DO NOT REMOVE
ACKNOWLEDGEDConsists of typical control wiring diagram
provided to replace Figure 2 of applicant's
4/25/77 submittal concerning certain ECCS
related valves.....

PLANT NAME: H.B. Robinson Unit No. 2

H. B. ROBINSON STEAM ELECTRIC PLANT UNIT NO.
LICENSE NO. DPR-23
DOCKET NO. 50-261
LOCKOUT OF CRITICAL ECCS VALVES

original design

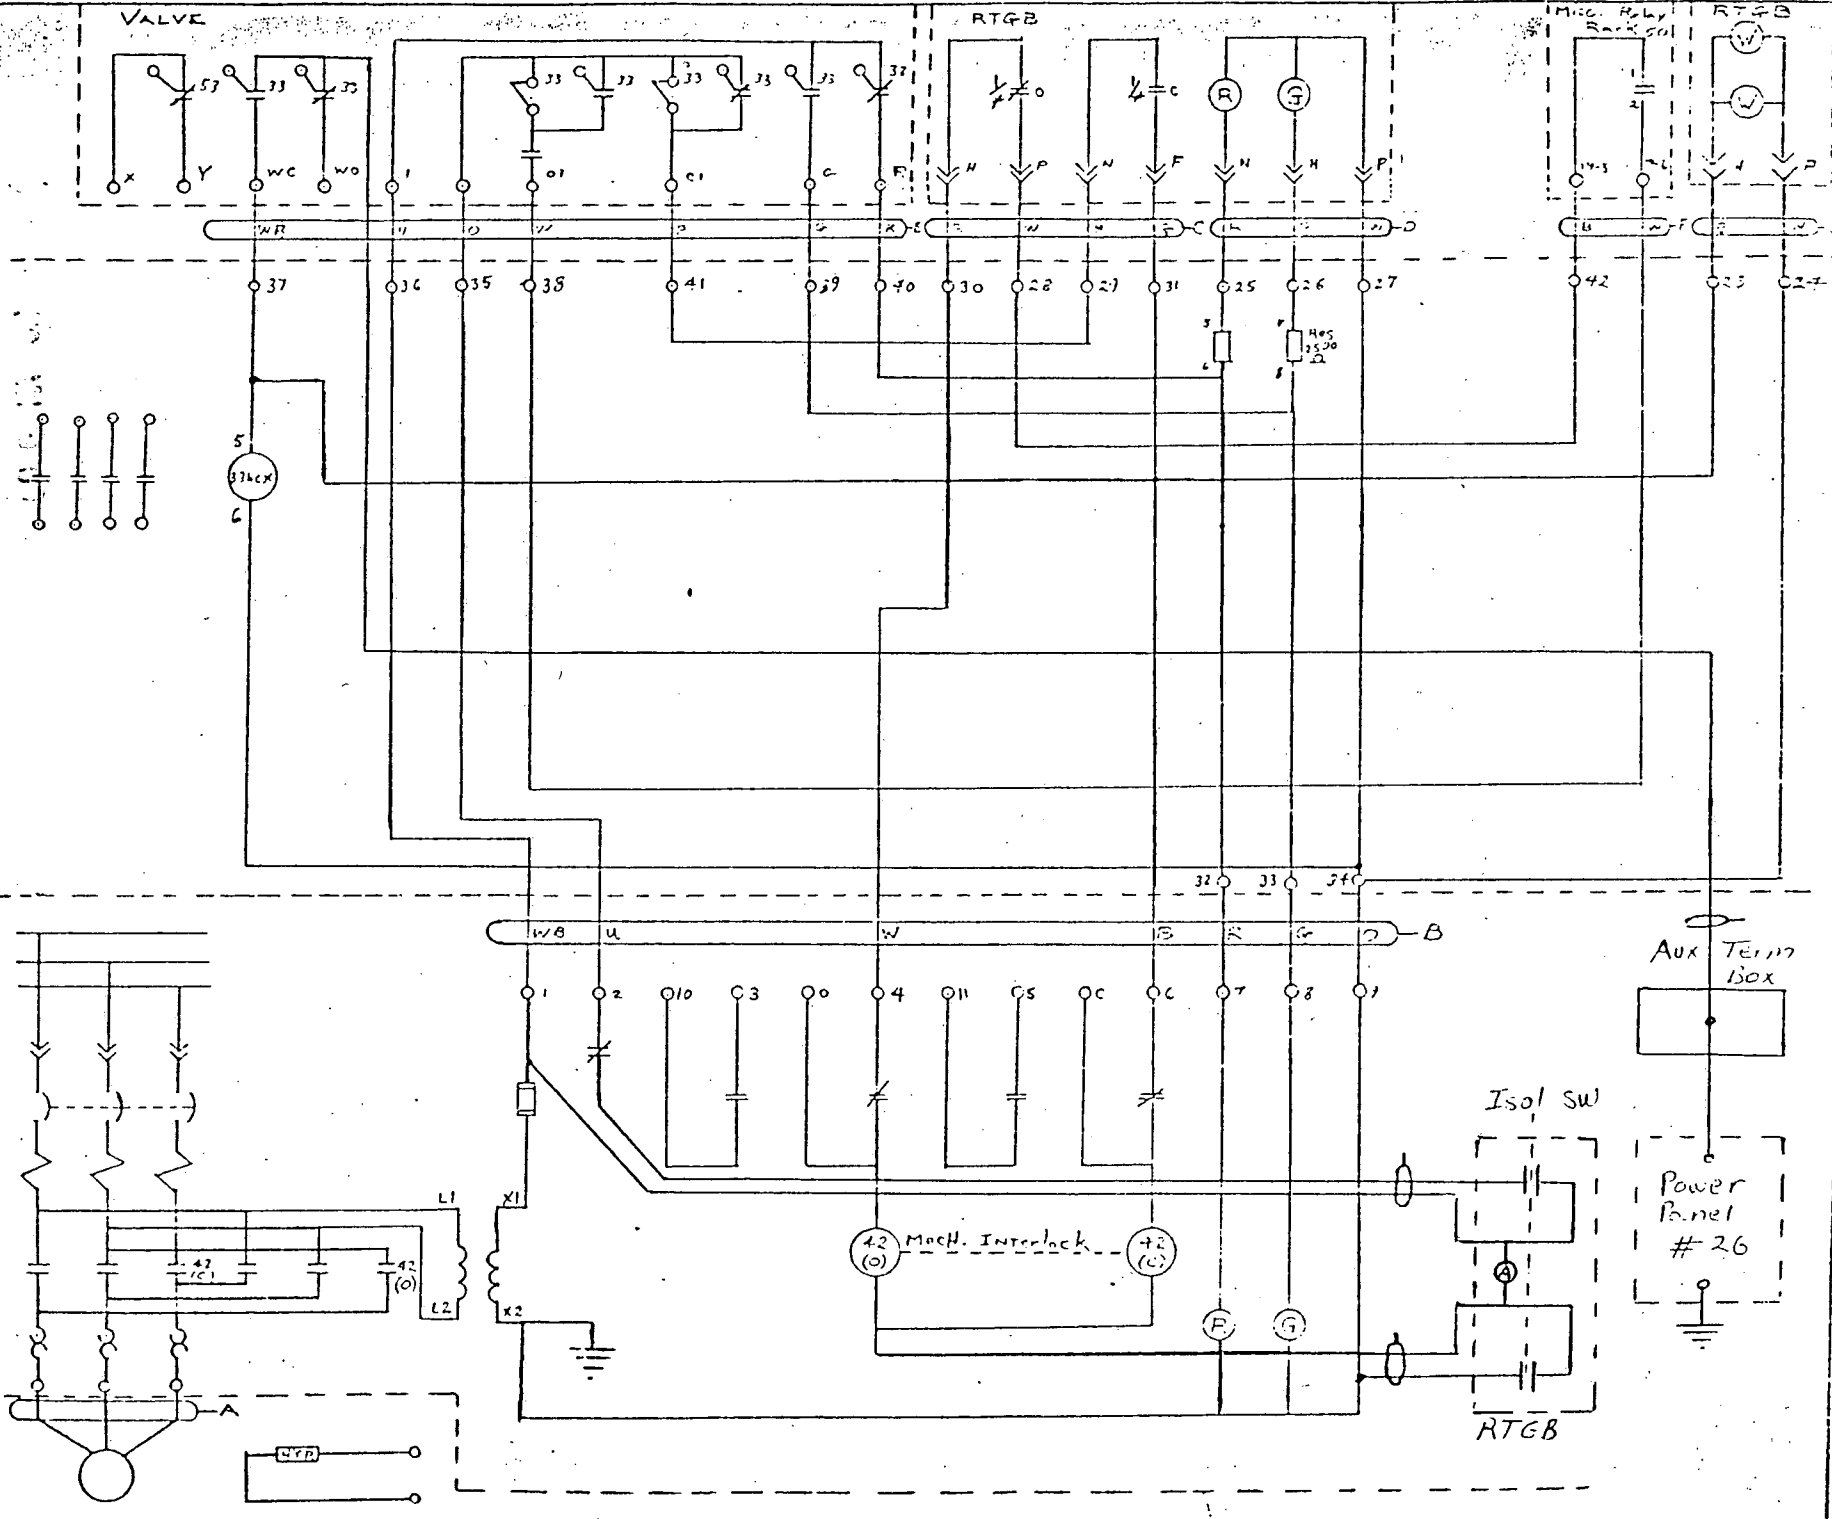
The attached typical control wiring diagram is provided to replace Figure 2 in our submittal of April 25, 1977. This typical control wiring diagram has been revised to isolate the control power to the valve and still retain power to the valve position indication circuit. The other provisions of the proposal remain unchanged.
